Decision Report

Application for Works Approval

Works Approval Number W6311/2019/1

Premises Jundee Operations
WILUNA WA 6646

Figure 5: TSF1 and TSF2 Groundwater contours as at June 2018 (Saprolite 2018)

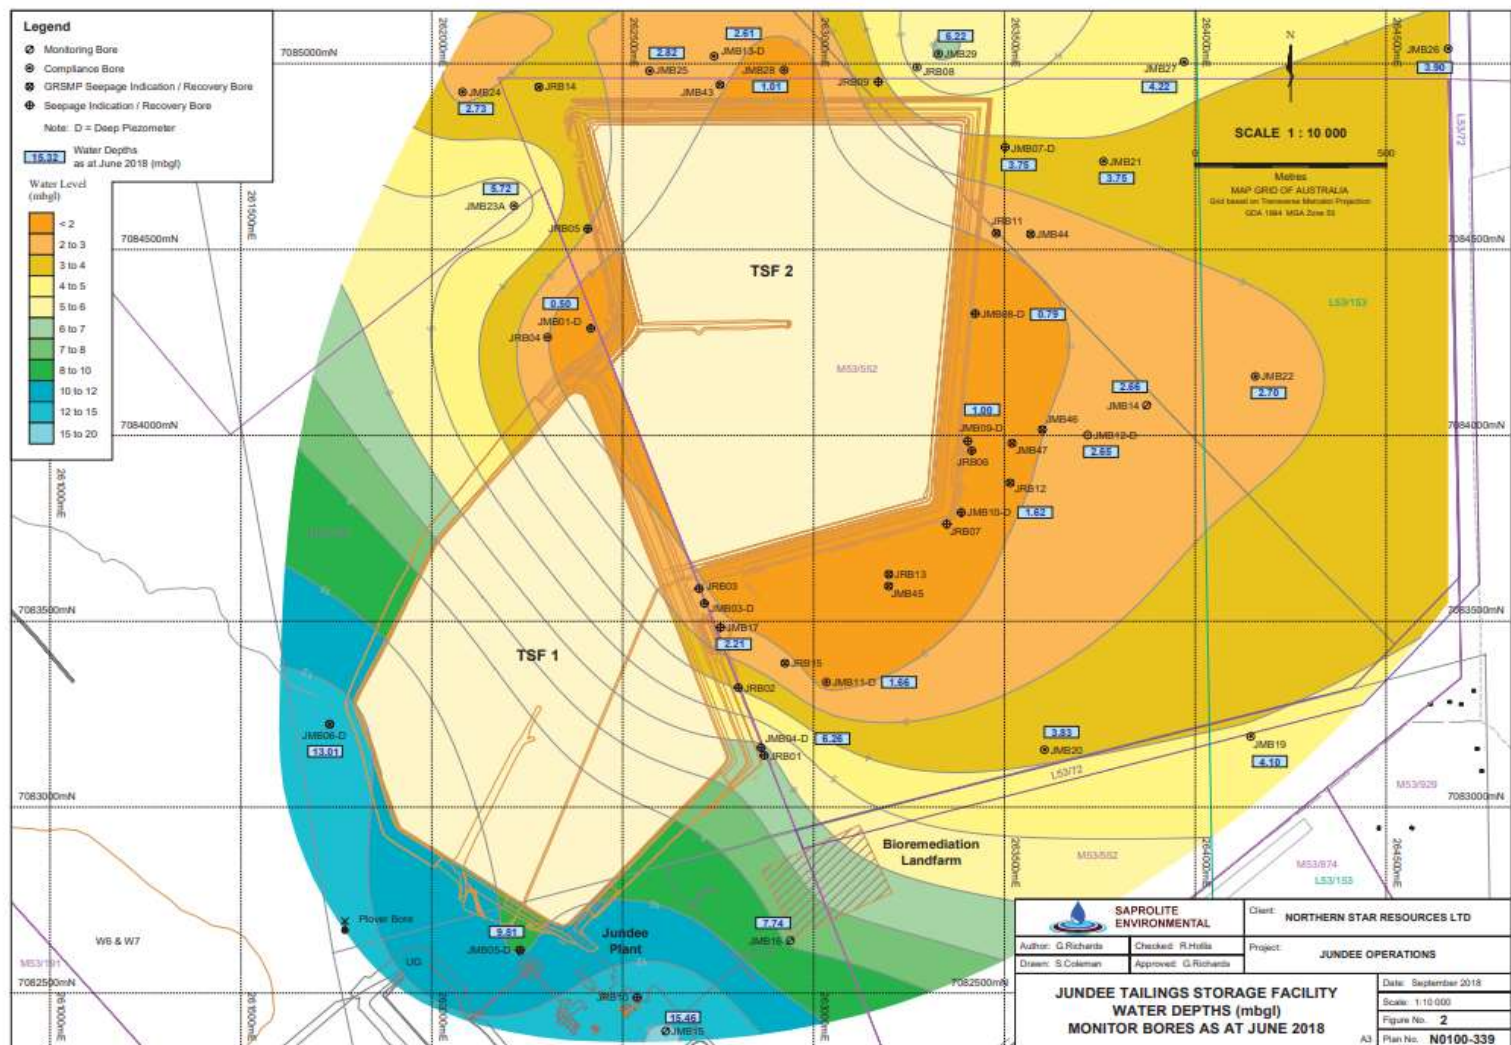
The majority of the rising groundwater issues are situated around TSF2. As TSF1 is immediately adjacent to TSF2, the assumption is that the groundwater impacts are influenced by operations in both TSF1 and TSF2. The groundwater contours, as described in Figure 5 above, show the groundwater flowing from TSF1 to TSF2, possibly contributing to the current

issues with rising groundwater. The Applicant has committed to updating their GRSMP to make the groundwater recovery more efficient. These include modifications to the TSF2 toe drain to improve removal of pooling waters and the upgrading of the groundwater recovery bores to ensure 24 hrs/day pumping, where previously, the majority of bores were solar powered and only pumping 6-8 hrs/day.
